To: T10 Technical Committee
From: Rob Elliott, HP (elliott@hp.com)
Date: 24 July 2006
Subject: 06-281r3 SAS-2 Enable and disable zoning

Suggested changes to sas2r04a as modified by 06-279r1

Figure 5 — Physical presence detection extending a ZPSDS example

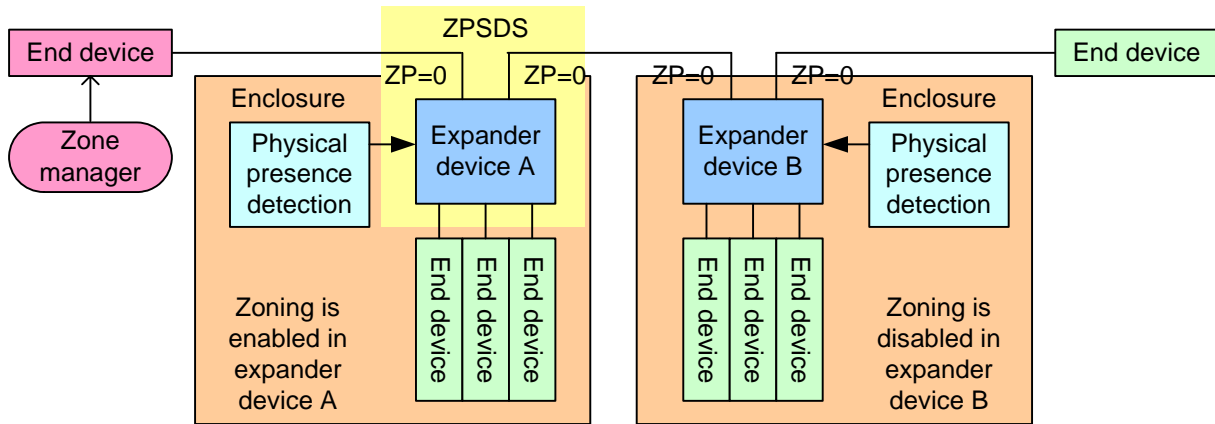
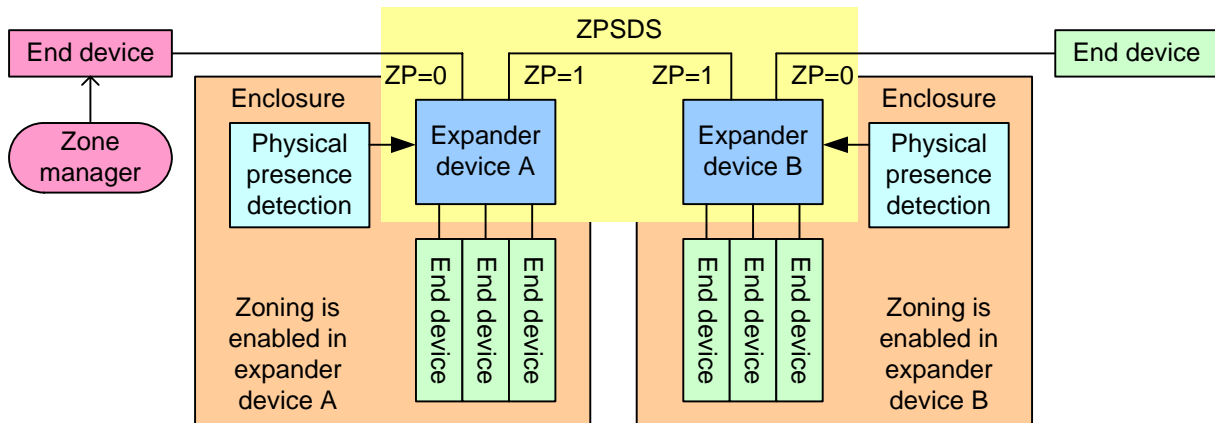
Figure 5 shows an example of two enclosures with physical presence detection where zoning is enabled in the expander device in the left enclosure, but is not enabled in the expander devices in the right enclosure. The zone manager is able to configure zoning in zoning expander device A because the zone group of its SMP initiator port has access to zone group 2. However, it is not able to enable or configure zoning in expander device B unless physical presence is asserted.

- 1) configures zone phy information in each expander device, including setting the ZONE PARTICIPATING bit to one in each expander phy that is going to be inside the ZPSDS; and
- 2) sends an ENABLE DISABLE ZONING request with the ZONING ENABLED bit set to one to expander device B while physical presence is asserted.

Figure 6 — Physical presence detection overtaking a ZPSDS example

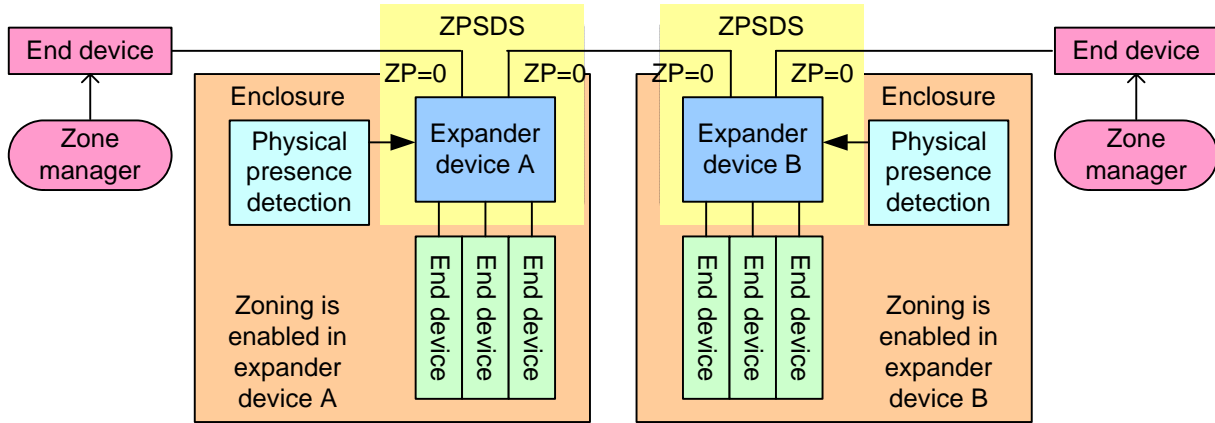
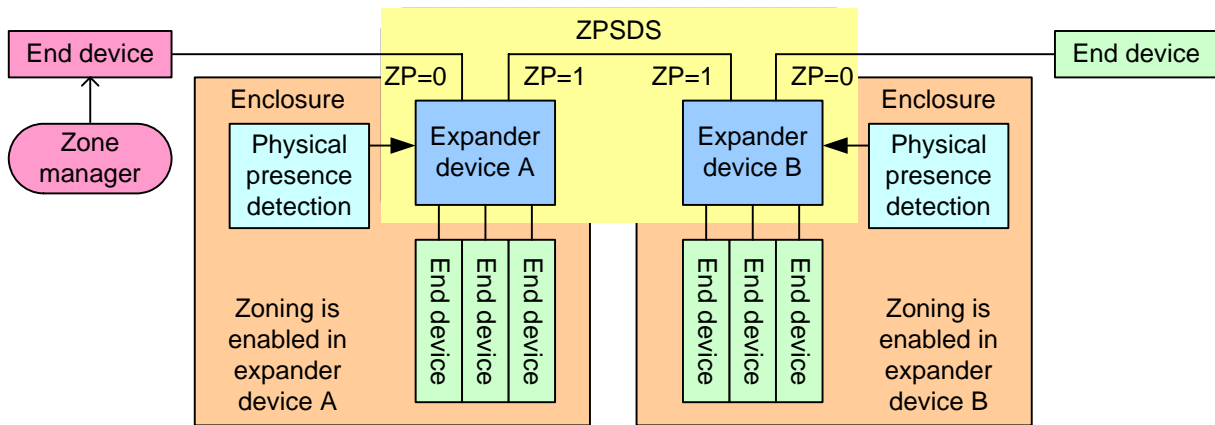
Figure 6 shows an example of two enclosures with physical presence detection where zoning is enabled in both the expander devices. The zone manager is able to configure zoning in zoning expander device A.

[because the zone group of its SMP initiator port has access to zone group 2. However, it is not able to configure zoning in expander device B unless physical presence is asserted.](#)

- 1) sends an ENABLE DISABLE ZONING request with the ZONING ENABLED bit set to zero to expander device B while physical presence is asserted;
- 2) configures zone phy information in each expander device, including setting the ZONE PARTICIPATING bit to one in each expander phy that is going to be inside the ZPSDS; and
- 3) sends an ENABLE DISABLE ZONING request with the ZONING ENABLED bit set to one to expander device B while physical presence is asserted
